UNITED STATES  
**NUCLEAR REGULATORY COMMISSION**  
REGION IV  
1600 EAST LAMAR BLVD  
ARLINGTON, TEXAS 76011-4511

**SUBJECT: SAN ONOFRE NUCLEAR GENERATING STATION – NRC AUGMENTED  
INSPECTION TEAM REPORT 05000361/2012007 and 05000362/2012007**

On March 19, 2012, an Augmented Inspection Team (AIT) was dispatched to San Onofre Nuclear Generating Station to gather facts and understand the circumstances surrounding the January 31, 2012 Unit 3 primary-to-secondary leak and failure of eight steam generator tubes to maintain structural integrity as required by plant technical specifications during testing the week of March 13, 2012. The primary-to-secondary leak was the result of a single tube in Unit 3 steam generator 3E0-88 failing to maintain structural integrity.

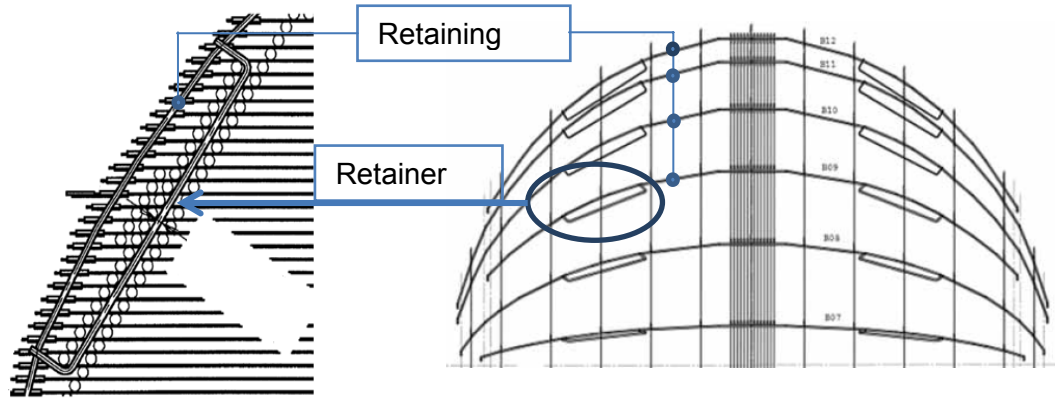
Description: In February 2012, the licensee identified wear indications in Unit 2 replacement steam generators at the tube locations in contact with the retainer bars (see figure below). Some of the indications showed excessive wear with a maximum degradation of 90 percent through wall.

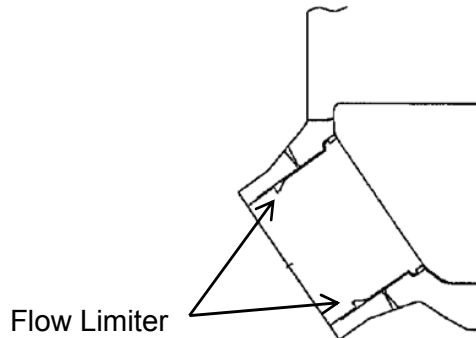
- Preliminary and ASME Section III Hydrostatic Tests – The number of hydrostatic tests performed in accordance with ASME Section III on the primary and secondary sides of the replacement steam generators varied between Units due to the results of the initial test in each steam generator. For each replacement steam generator, the hydrostatic tests were performed first on the primary side and then on the secondary side. Both Unit 2 steam generators met the acceptance criteria in the first hydrostatic test. However, during the first hydrostatic test on the secondary side of Unit 3 steam generator 3E0-89, Mitsubishi identified leakage through a tube-to-tubesheet weld that exceeded the ASME Code acceptance criteria. After repairs were completed to address the leakage, the hydrostatic tests were re-performed. Following the second set of hydrostatic tests on Unit 3 steam generator 3E0-89, cracking indications were identified in the divider plate-to-channel head weld. After repairs were completed to address the divider plate weld cracks, a third set of hydrostatic tests were performed in Unit 3 steam generator 3E0-89. Since similar cracking indications

of the divider plate weld were identified in Unit 3 steam generator 3E0-88, a second set of hydrostatic tests was performed in this steam generator after the divider plate weld was repaired.

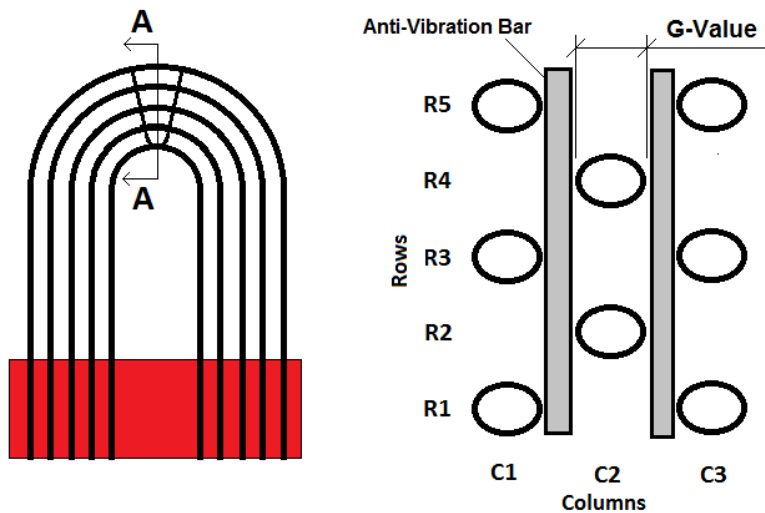
- Anti-Vibration Bar Spacing Issues in Unit 2 Steam Generator 2E0-89 – During fabrication of Unit 2 replacement steam generator 2E0-89, quality control inspections identified unacceptable gaps between tubes and the anti-vibration bars in the outside tube columns. The affected area was identified as welding zone-4. The apparent cause for the anti-vibration bar spacing issue was due to performing the welding of zone-4 while the steam generator was oriented horizontally with this welding zone oriented to the bottom of the bundle. In this configuration, the tube bundle experienced sagging at the time of welding due to gravity. After completion of welding zone 4, the steam generator assembly was rotated 180 degrees for additional assembly steps, but the sagging in the opposite direction caused enlargement of the gaps in welding zone 4 and this enlargement remained approximately the same for all subsequent rotations. When zone-4 was rotated 180-degrees after welding, deflection or sagging of the tube retaining bars due to gravity slightly pulled the anti-vibration bars, increasing the gap between the tube and the anti-vibration bars in this zone.

With the licensee’s approval, Mitsubishi implemented various corrective actions to address the condition in the pending Unit 2 replacement steam generator 2E0-88 and subsequently in Unit 3 steam generators which included: (a) use of smaller spacer blocks between tubes for the installation of anti-vibration bars, (b) re-define the welding zones to limit welding in the horizontal position, and (c) reduce rotations during welding of the other bundle zones. Mitsubishi performed rework activities in Unit 2 steam generator 2E0-89 to restore anti-vibration bar spacing to design specifications. These activities resulted in better gap distribution. All the tube-to-anti-vibration bar gaps exceeding the initial dimensional criteria were further evaluated and accepted in accordance with Mitsubishi’s gap size evaluation procedure.

**Figure 2**

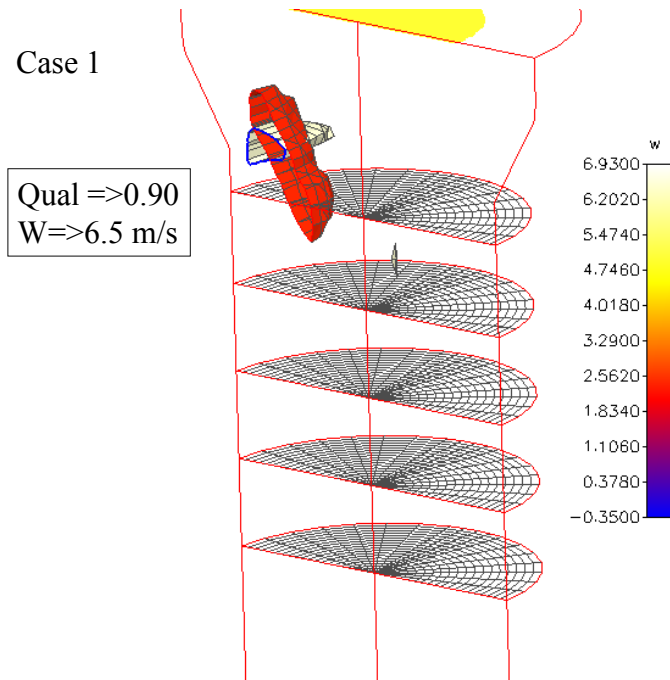
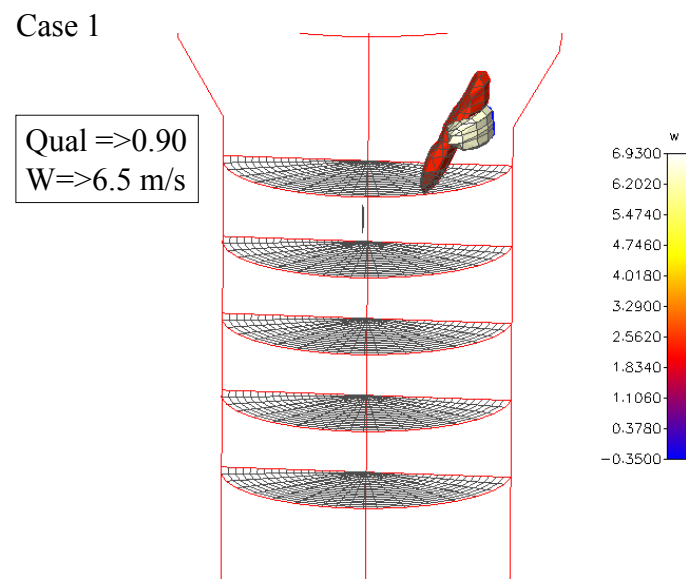
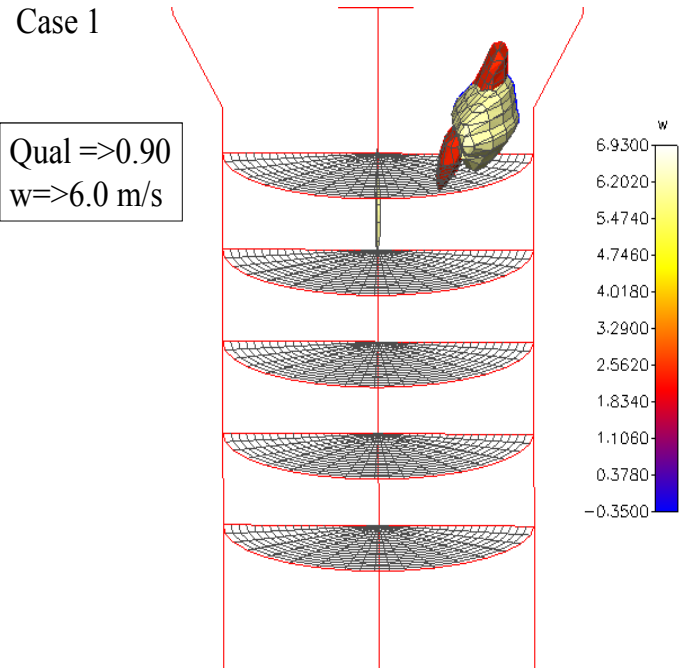
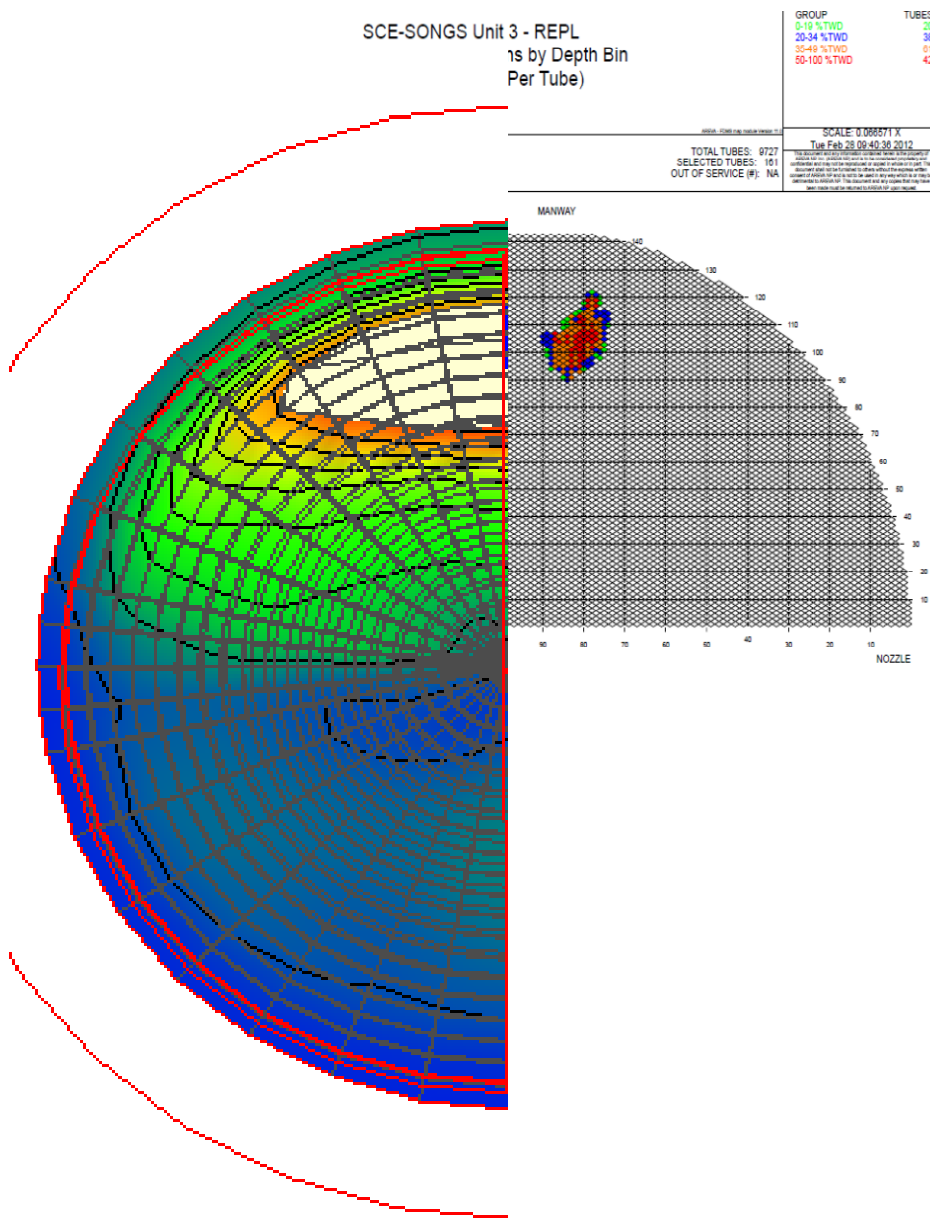
The ATHOS code predicted regions of high void fraction and high steam velocities are superimposed with tube-to-tube wear indications from Unit 3 steam generator 3E0-88

The NRC analysis indicated a correlation with the tube-to-tube wear based on a combination of high void fraction and high steam velocities. It should be noted that the traditional forcing function, fluid velocity squared times density, does not show good agreement with the tube-to-tube wear patterns. This indicated that the high quality steam fluid velocities and high void fraction may be sufficiently high to cause conditions in the generators conducive for onset of fluid-elastic instability.
